PLANNING, ZONING, & BUILDING DEPARTMENT
PZ&B Staff Memorandum: Architectural Commission (ARCOM)

SUBJECT: ARC-24-0022 (ZON-22-0014) 1246 N LAKE WAY

MEETING: JULY 24, 2024 ARCOM
AUGUST 12, 2024 TC

ARC-24-0022 (ZON-24-0014) 1246 N LAKE WAY (COMBO)- VARIANCES. The applicant, Myron and Michelle Miller, has filed an application requesting Architectural Commission review and approval to enclose an existing covered patio with a variance to exceed allowable Cubic Content Ratio. Town Council shall review the application as it pertains to zoning relief/approval.

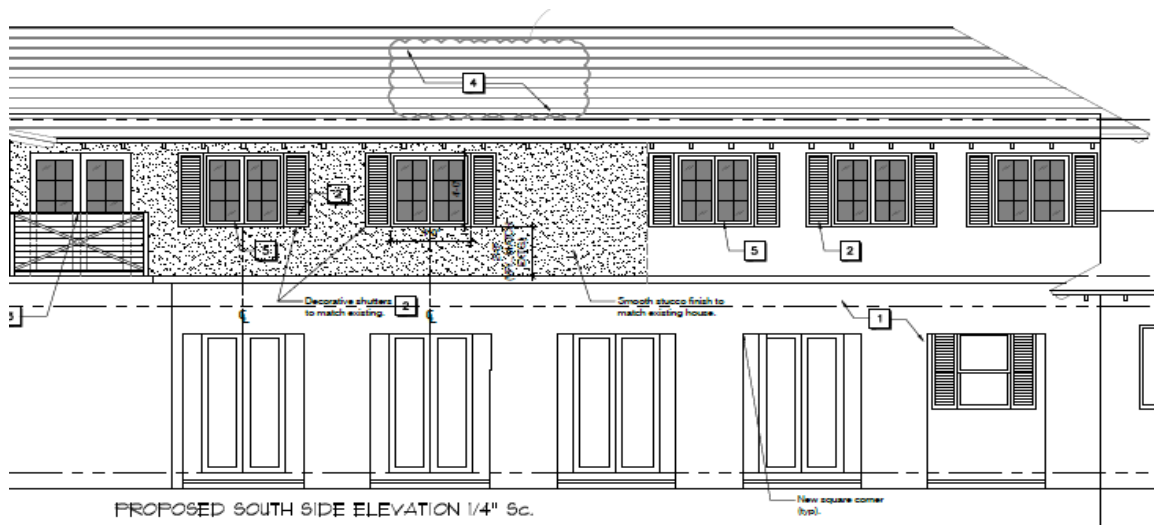
- Enclosure of a first floor loggia and second story balcony.

- **Variance 1:** Sec. 134-893(13): A variance to exceed the maximum allowable cubic content ratio (CCR) to 4.14 in lieu of the 3.96 permitted.
